Subject: Class 3 Permit Modification Request, Construction and Use of Hazardous Waste Disposal Units 11 and 12 for the Waste Isolation Pilot Plant Hazardous Waste Facility Permit Number: NM4890139088-TSDF

Class 3 Permit Modification Request

Construction and Use of Hazardous Waste Disposal Units 11 and 12

**Waste Isolation Pilot Plant
Carlsbad, New Mexico**

Figure A2-2
Spatial View of the Miscellaneous Unit and Waste Handling Facility

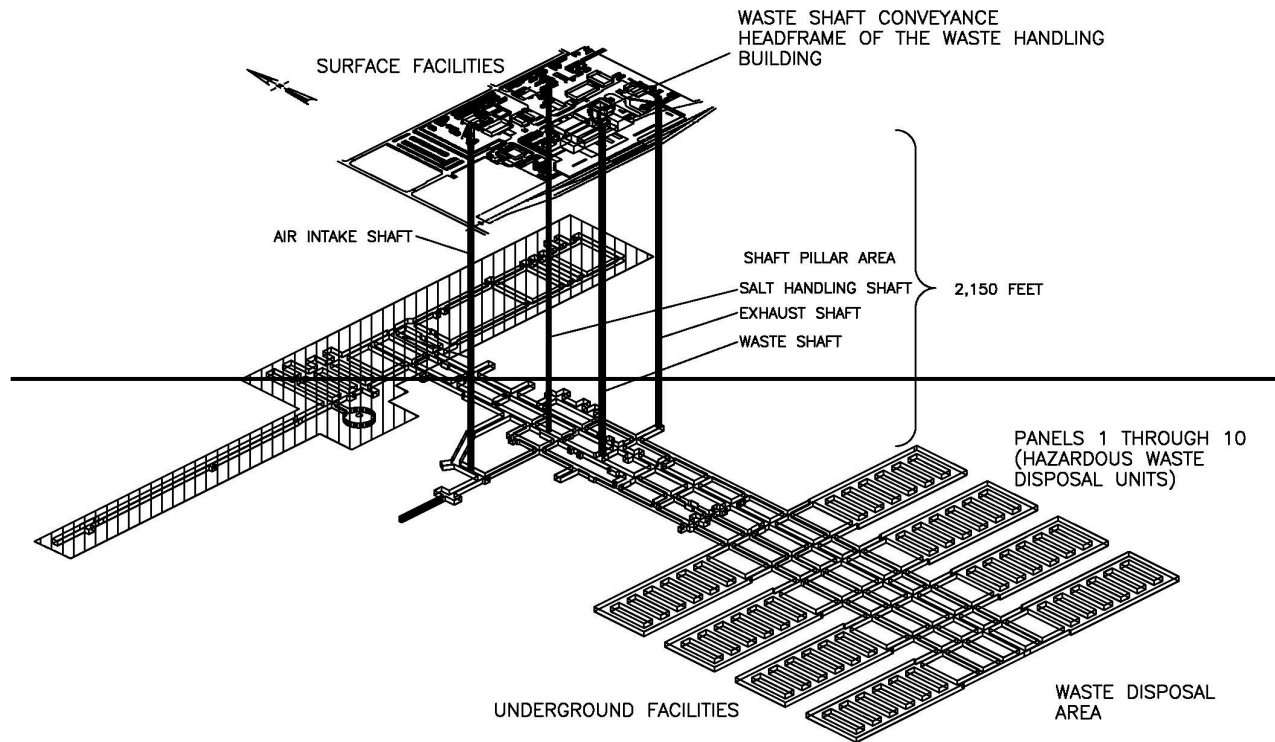
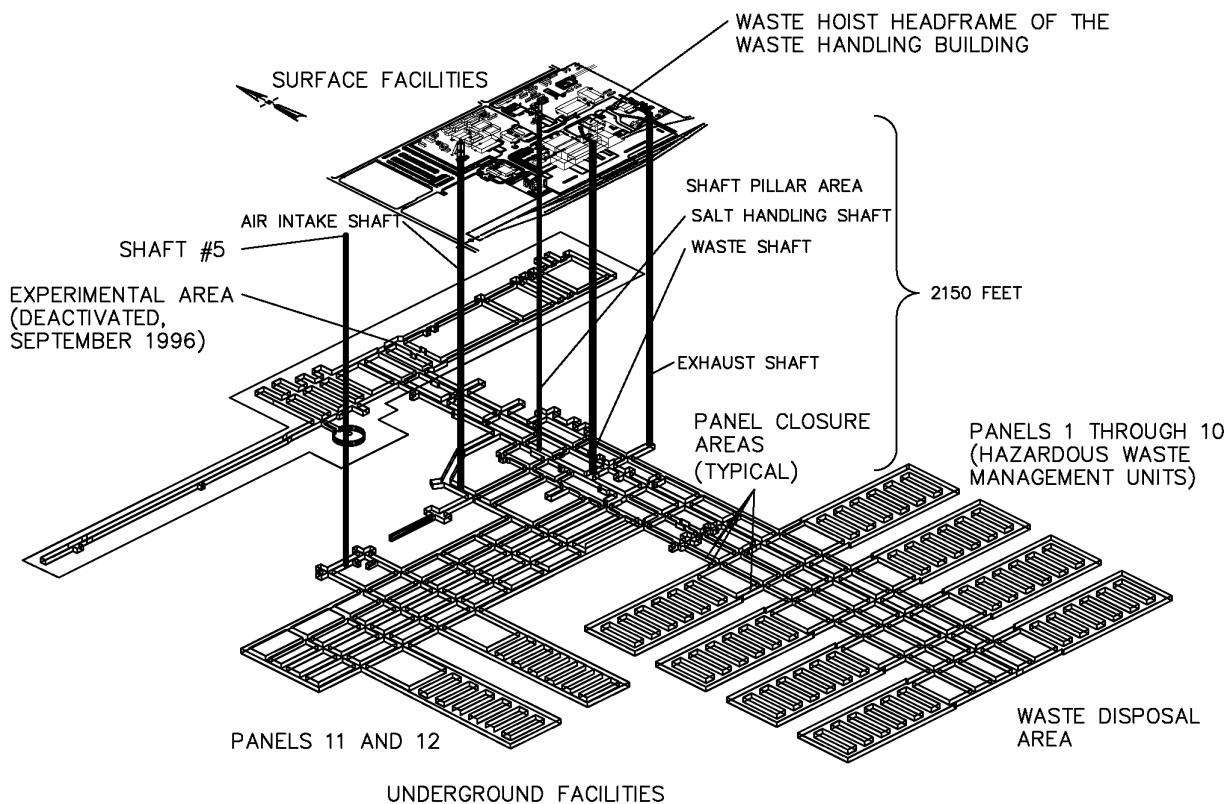
- Permit Attachment A2, Section A2-1, *Description of the Geologic Repository*, is being modified to include the 29.2 acre mined area to the west, to include Panels 11 and 12 where appropriate, and to modify the maximum waste volume capacity available for TRU mixed waste emplacement. Additionally, Figures A2-1, *Repository Horizon* and A2-2, *Spatial View of the Miscellaneous Unit and Waste Handling Facility*, are being modified to show the location of the West Mains and Panels 11 and 12.

Typical Disposal Panel

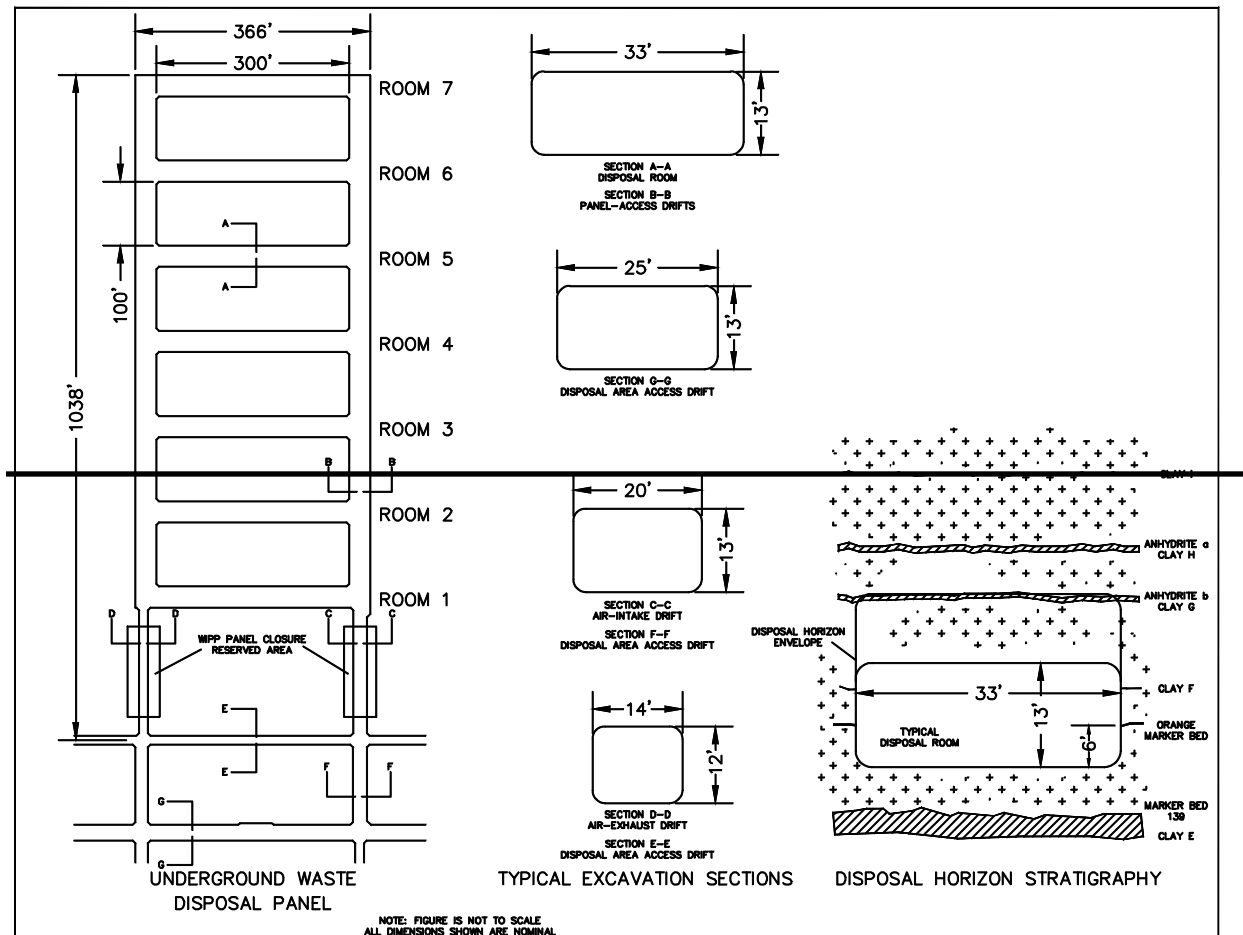
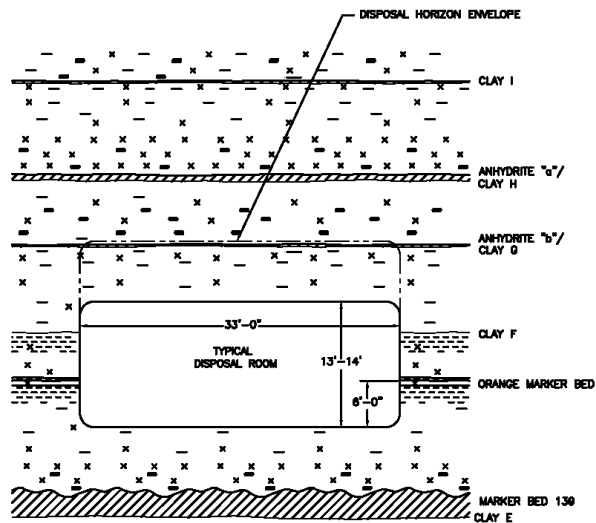
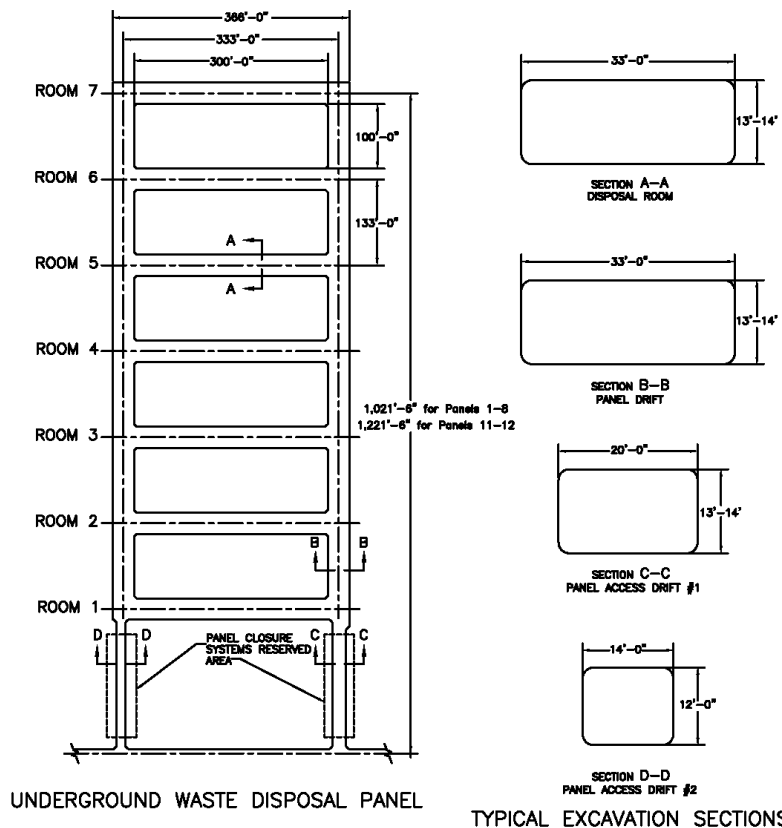
Affected Permit Section	Explanation of Change
	changing the word “areas” to “access drifts” and to eliminate Panel 9 from the waste emplacement discussion.
Attachment A2, Section A2-2b	Modified the 2 nd to the last paragraph, changing “Underground” to all lower-case letters and adding Panels 11 and 12 to the sentence talking about the anticipated schedule for filling each of the panels.
Attachment A2, Section A2-5b(2)(a)	Changed the number of panels from “eight” to “ten” in the third paragraph. Changed “will be” to “is”.
Attachment A2, Figures	Replaced Figure A2-1, <i>Repository Horizon</i> , by adding the West Mains and Panels 11 and 12 to the repository layout.
Attachment A2, Figures	Replaced Figure A2-2, <i>Spatial View of the Miscellaneous Unit and Waste Handling Facility</i> , to include the West Mains and Panels 11 and 12.
Attachment A3, <i>Typical Disposal Panel</i>	Replaced the figure, <i>Typical Disposal Panel</i> , to show the length of the panel as 1,021’-6” for Panels 1-8 and 1,221’-6” for Panels 11 and 12. Modified Section A-A’ to show the disposal room height at 13’-14’.

Figure A4-4b
Typical Underground Transport Route Using S-700 or S-850

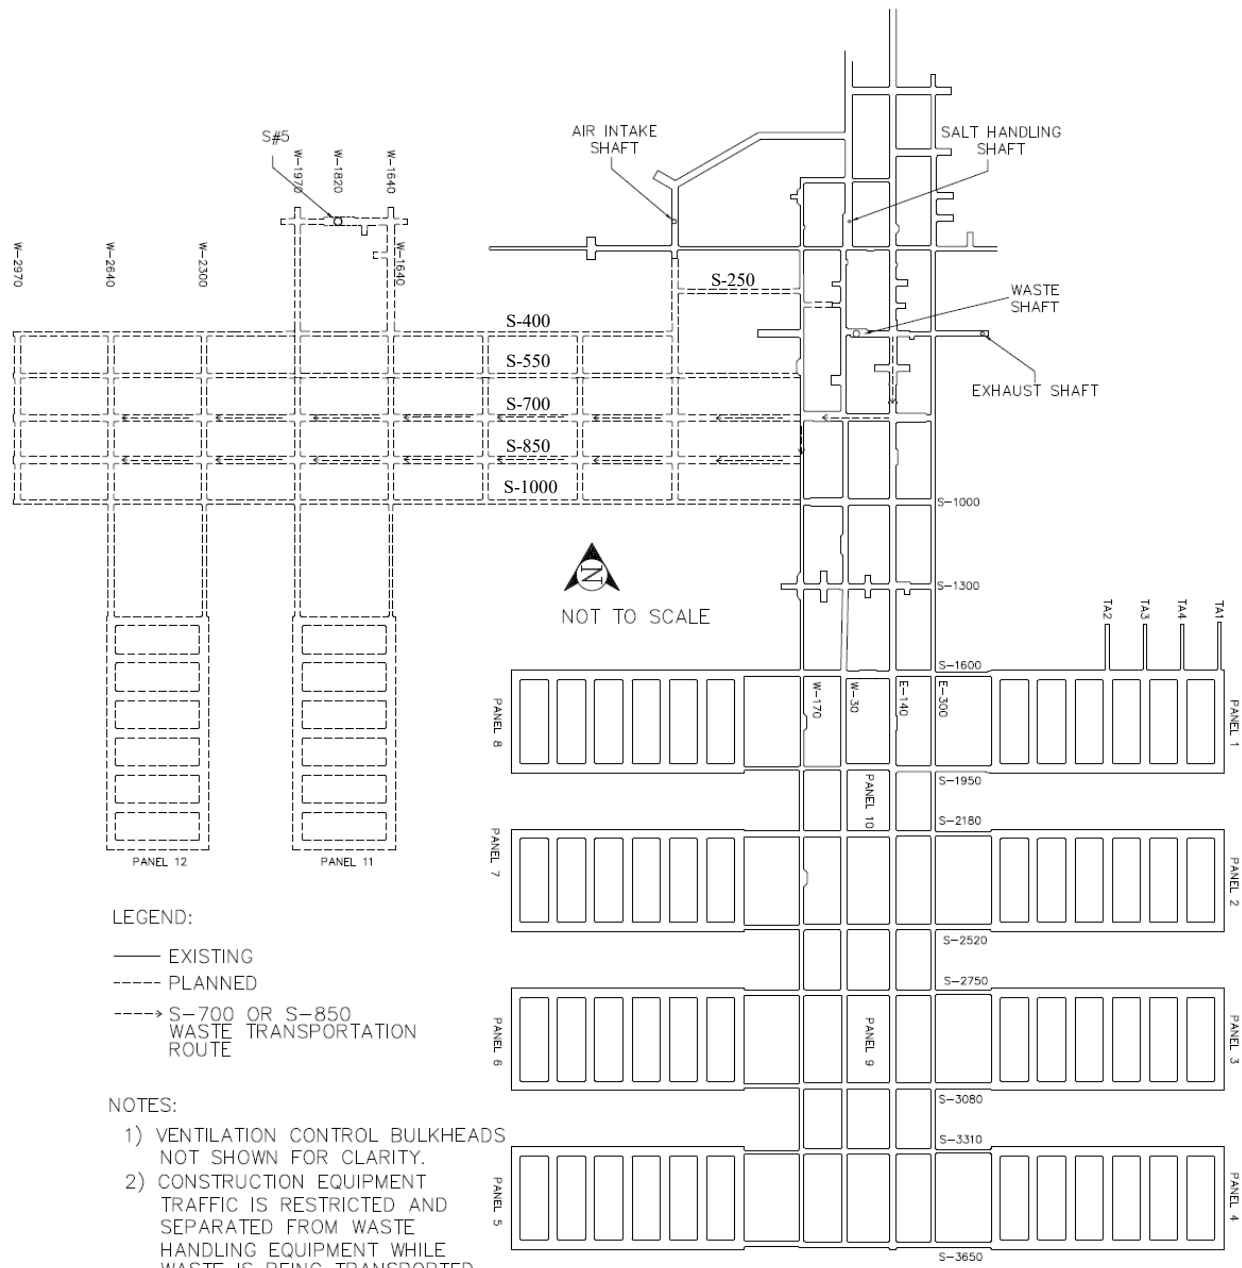
- Permit Attachment A4, Figure A4-4b, *Typical Underground Transport Route using S-700 or S-850*, is being added to show the waste transport routes for Panels 11 and 12. Additionally the *List of Figures* is being modified to include Figure A4-4b. Figures A4-4, *Typical Underground Transport Route Using E-140*, and A4-4a, *Typical Underground Transport Route Using W-30*, are being modified to show the proposed West Mains and Panels 11 and 12 in order to ensure accuracy of the figures.

Attachment A4, Figures	Added a new figure, Figure A4-4b, <i>Typical Underground Transportation Route Using S-700 or S-850</i> to show the planned transport route for waste to Panels 11 and 12. This figure is needed to show the planned waste transport routes in the West Mains.
Attachment B, Hazardous Waste Permit Part A Form	Added Panels 11 and 12, along with their Process Design Capacity to the table at 6. <i>Process Codes and Design Capacities (continued)</i> . Also modified the narrative to Item 6, <i>Process Codes and Design Capacities</i> , to show ten panels as opposed to eight panels in the first paragraph. Modified the second paragraph to show the maximum design capacity volume with Panels 11 and 12. Changed "eight" underground HWDUs to "ten" underground HWDUs in the third paragraph. Added two sentences to the end of the fourth paragraph stating that Panels 11 and 12 will be constructed during the term of this permit and the maximum CH and RH disposal capacities that the panels will be certified for. These changes are needed to accurately describe the number of underground HWDUs and their design capacity.

Figure B3-1
Spatial View of the WIPP Facility

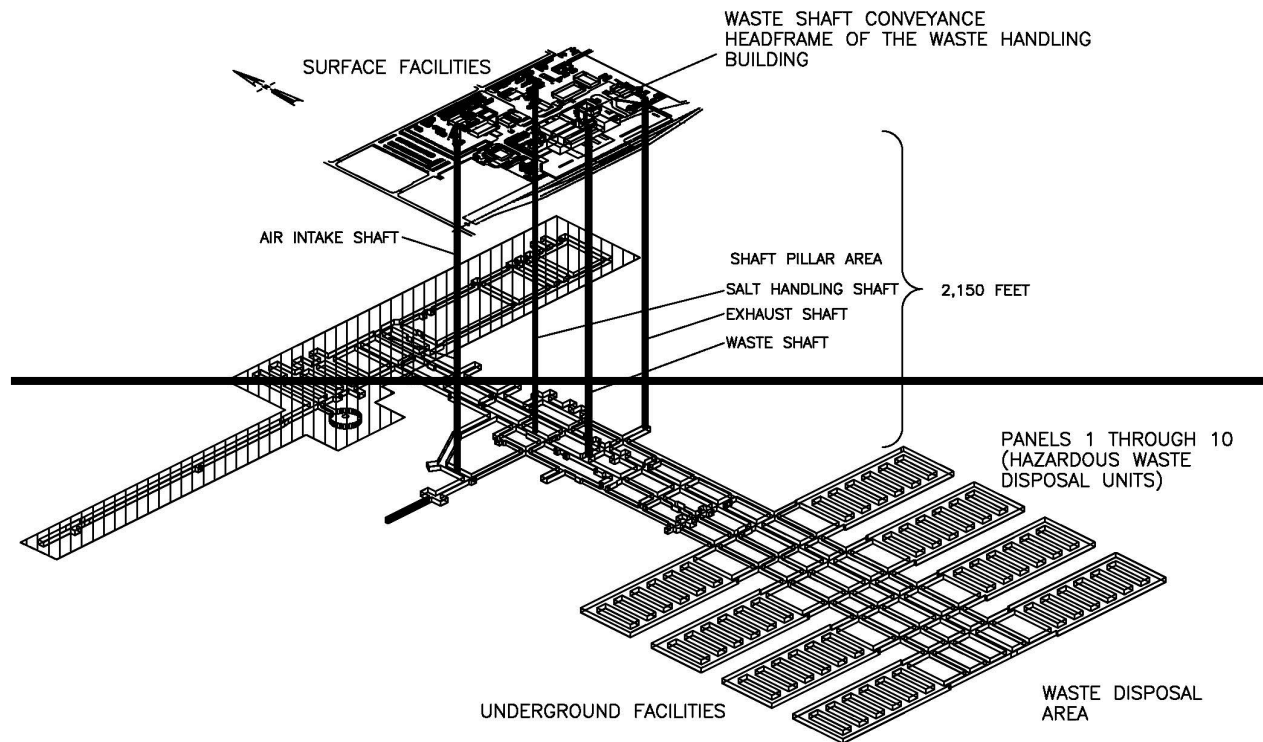
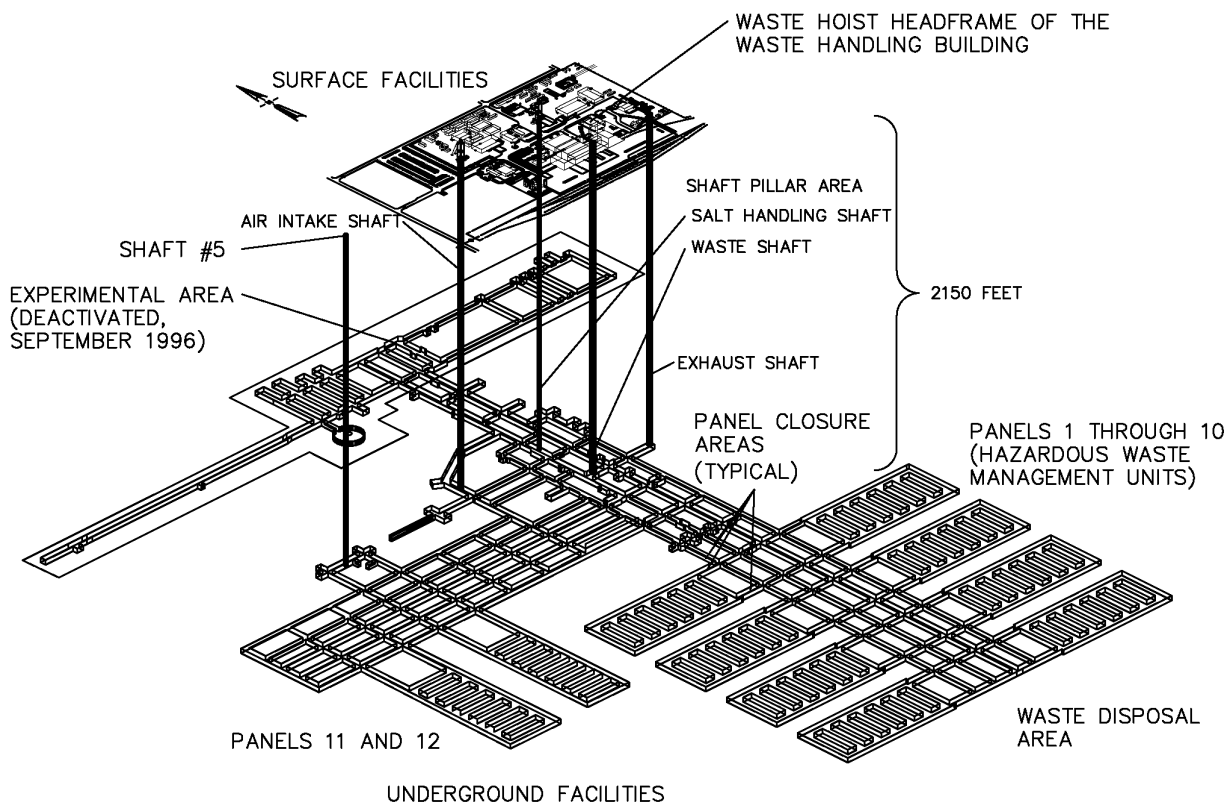
- Permit Attachment B, Appendix B3, Figure B3-1, *Spatial View of the WIPP Facility*, is being modified to include the West Mains and Panels 11 and 12.

Attachment B, Appendix B3	Modified Figure B3-1, <i>Spatial View of the WIPP Facility</i> , to accurately show the West Mains and Panels 11 and 12. This modification is needed to accurately show the planned underground repository.
Attachment B, Appendix B3	Modified Figure B3-2, <i>Repository Horizon</i> , to accurately show the West Mains and Panels 11 and 12. This modification is needed to accurately show the planned underground repository.
Attachment D, Figures	Modified Figure D-2, <i>Spatial View of the WIPP Facility</i> , to show the planned underground repository layout with the West Mains and Panels 11 and 12. This modification is needed to accurately depict the planned underground repository layout.
Attachment D, Figures	Modified Figure D-3, <i>WIPP Underground Facilities</i> , to show the planned underground repository layout with the West Mains and Panels 11 and 12. This modification is needed to accurately depict the planned underground repository layout.
